Project: 90009590 - I-405 - Brickyard to SR527  
 Bothell, Washington 98011

## BY-CRE-03798\_009727\_RFI\_00627\_16.03.02\_BRT Below Grade Waterproofing Revisions Missed Prior to RFC

Washington State Department of Transportation  I-405, Brickyard to SR 527 Improvement Project Contract No. 009727	Doc Type: RFI
		REV#: 0
		SPEC SECTION:
		DATE: 10/22/2025
		CRE #: BY-CRE-03798

DRAWING NO.: **BT230-AED200**  
FACILITY ID: BT230  
SHEET No: REV: 0

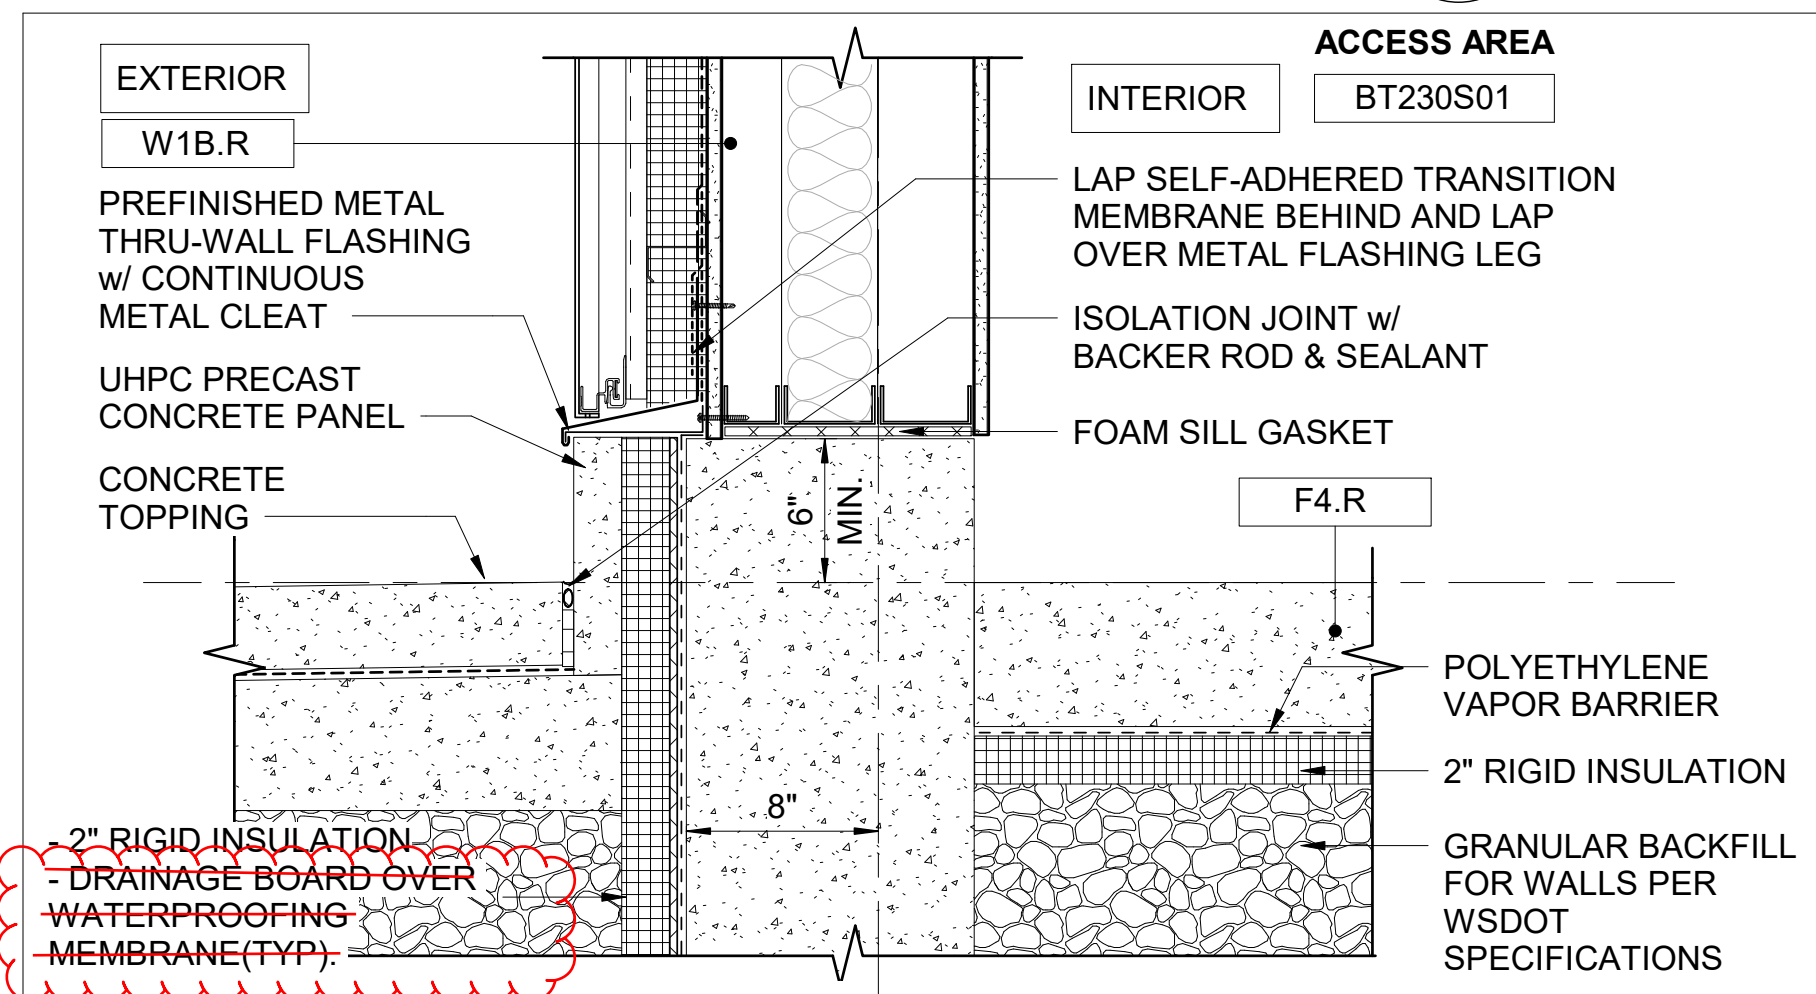
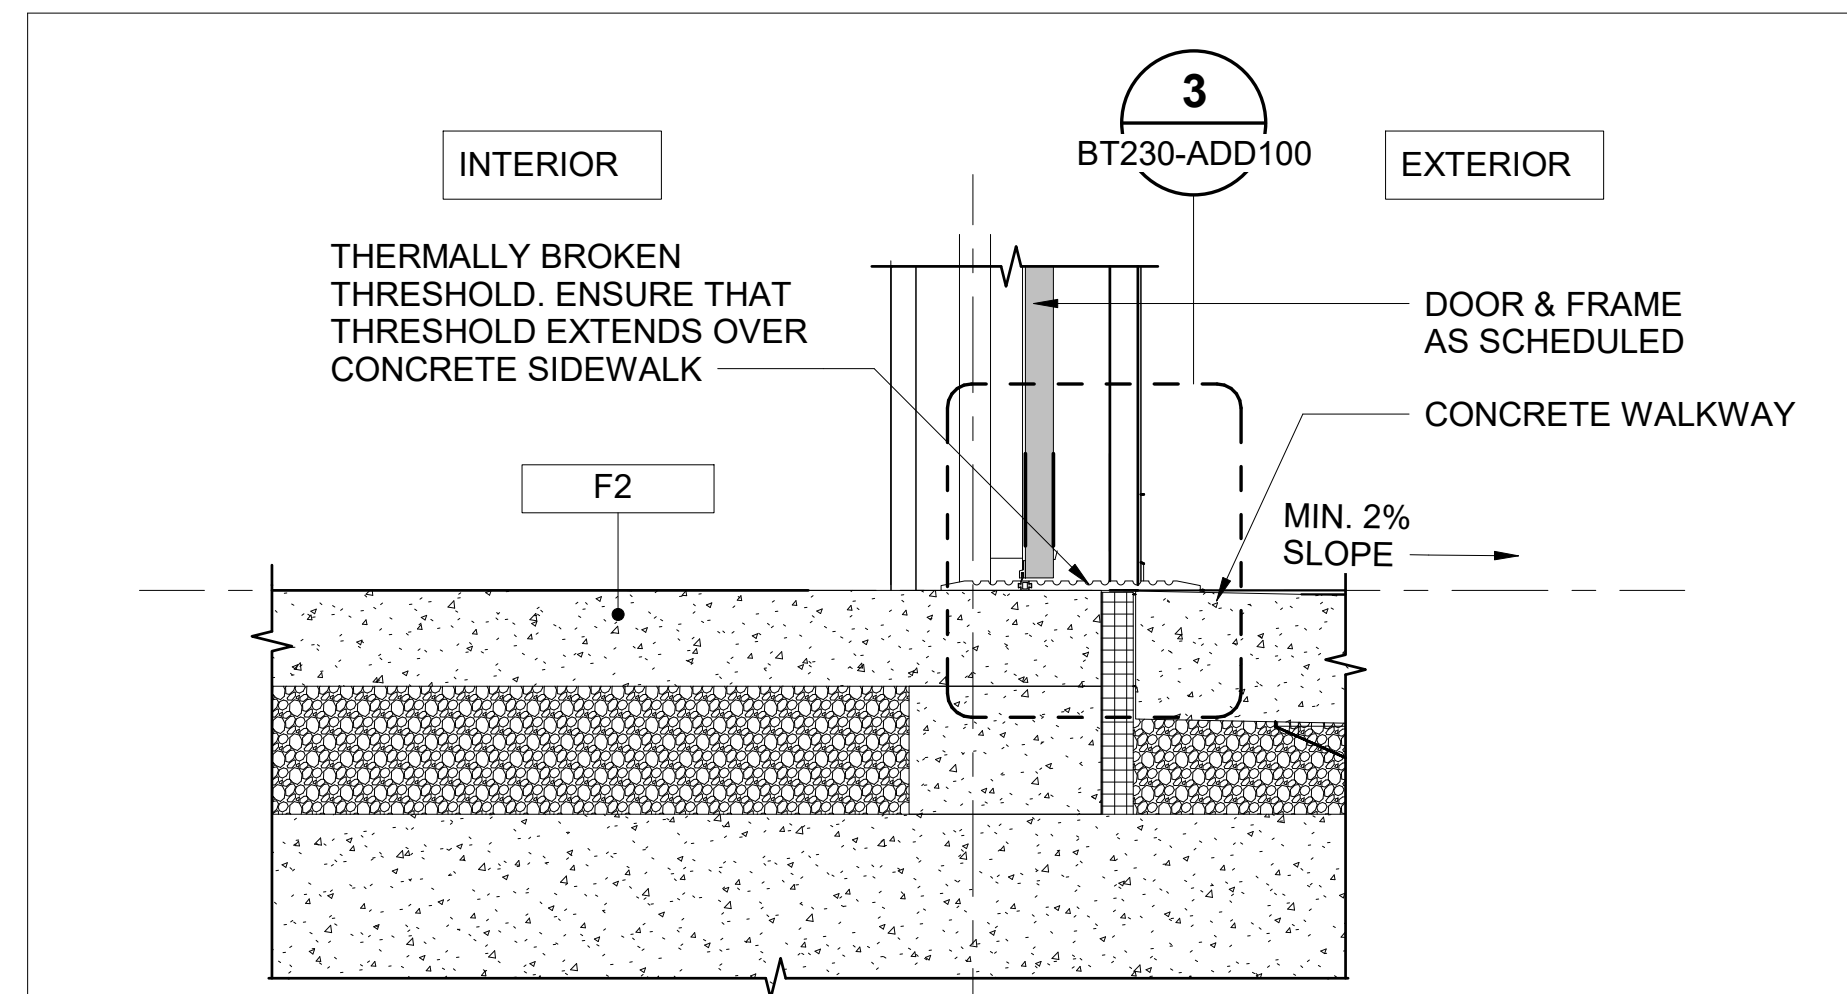
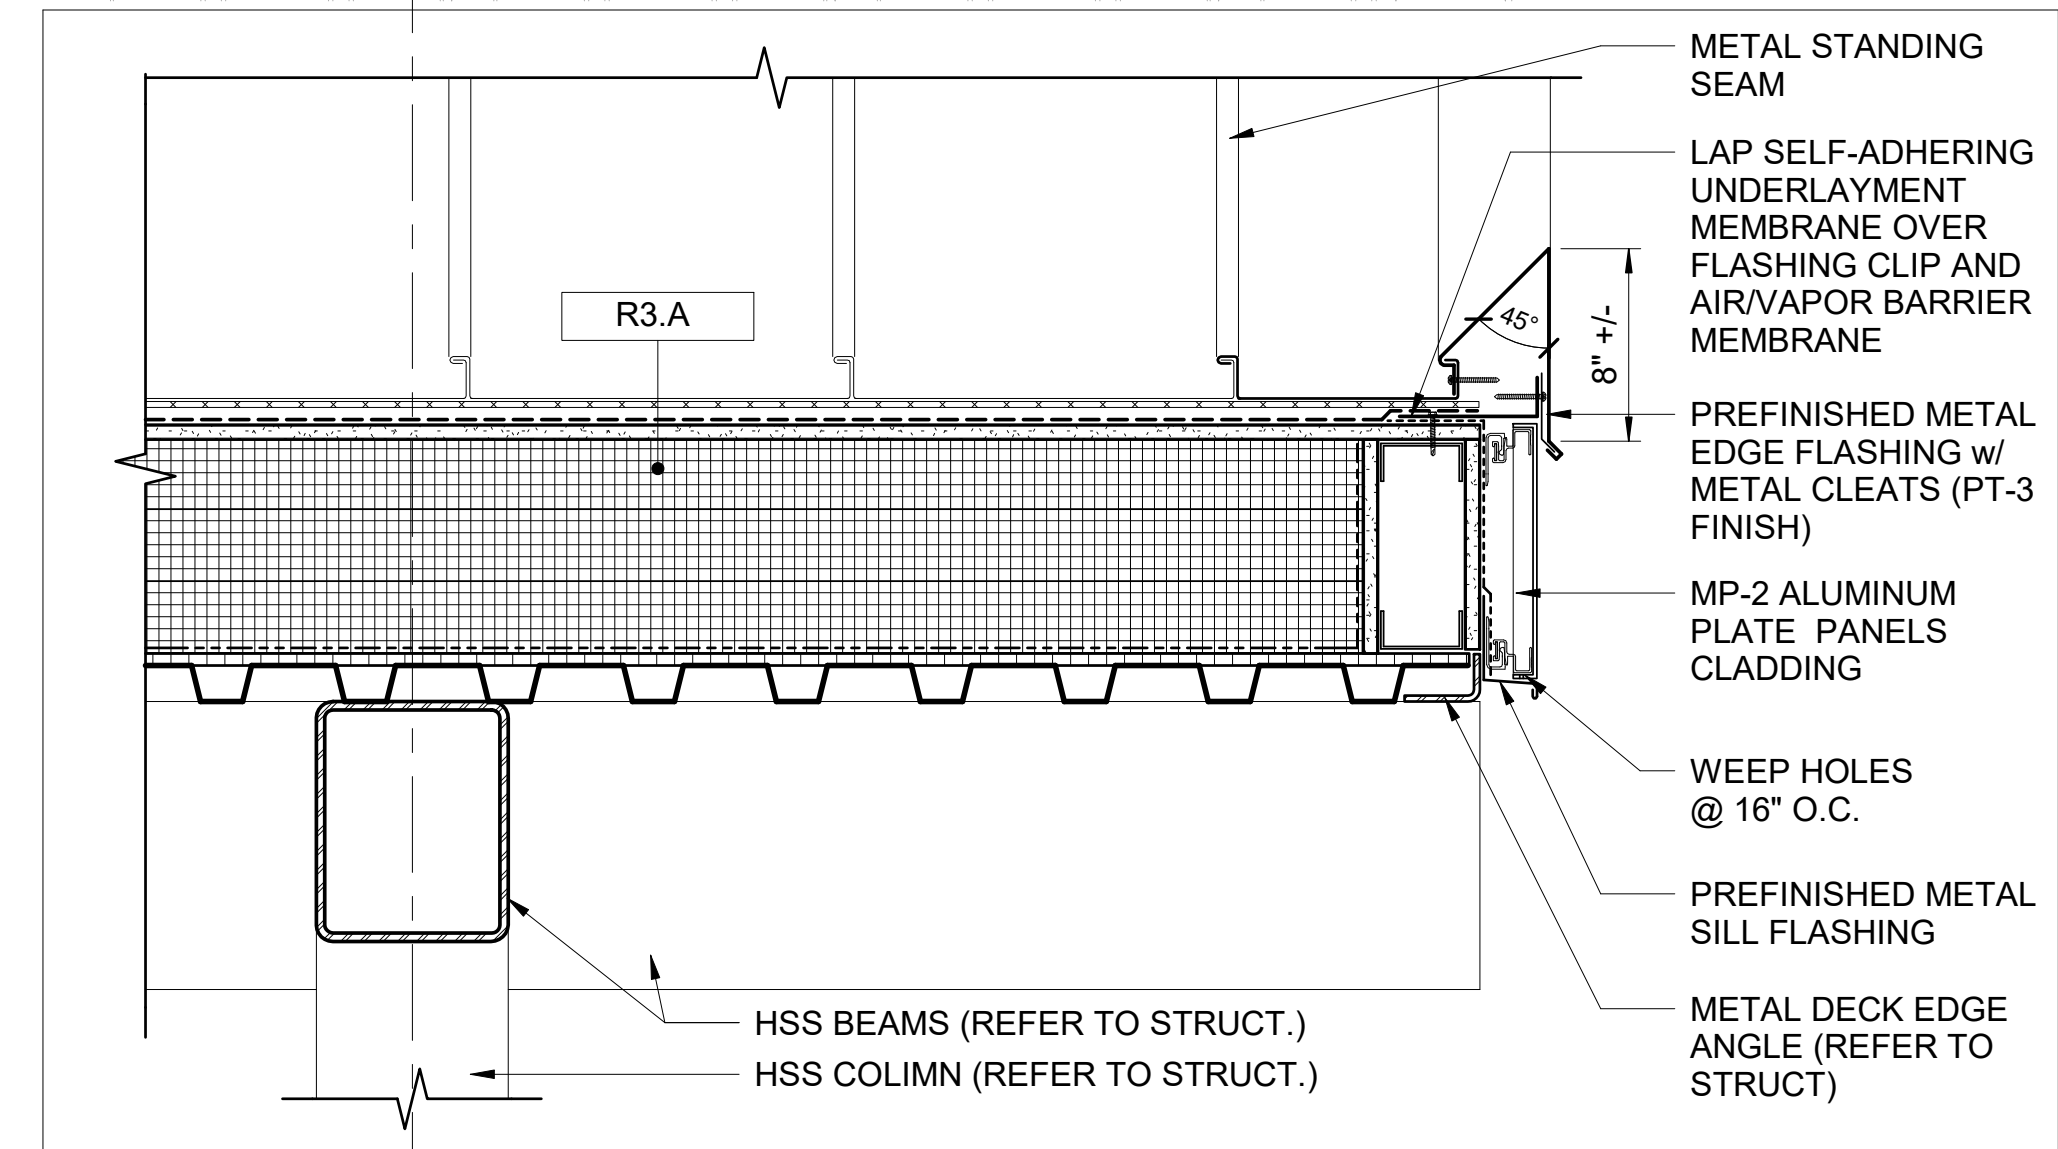
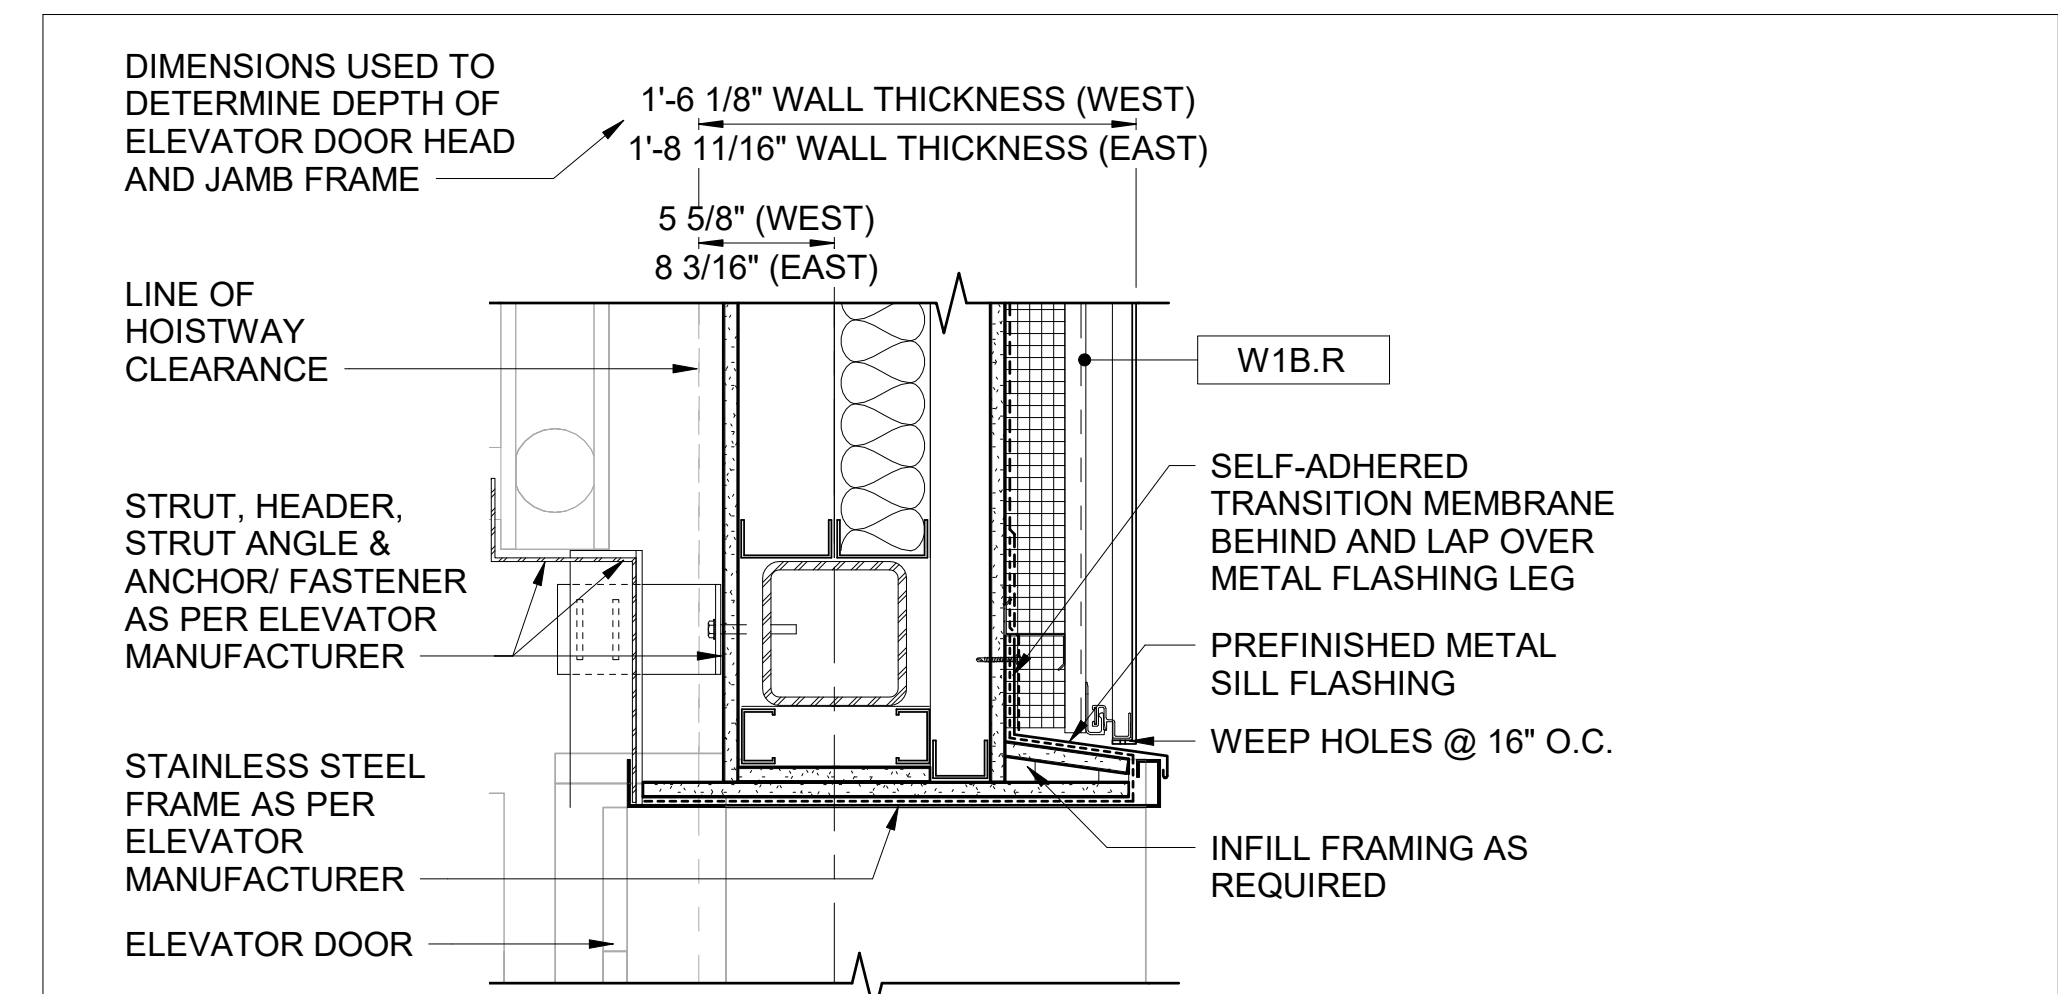
Q. AECOM please confirm all below grade waterproofing that has been marked on the attached drawings should have been removed prior to RFC.

**AECOM response:** Yes, waterproofing should be removed in marked up areas to be consistent with section AVX150 and AEX series where the waterproofing was omitted.
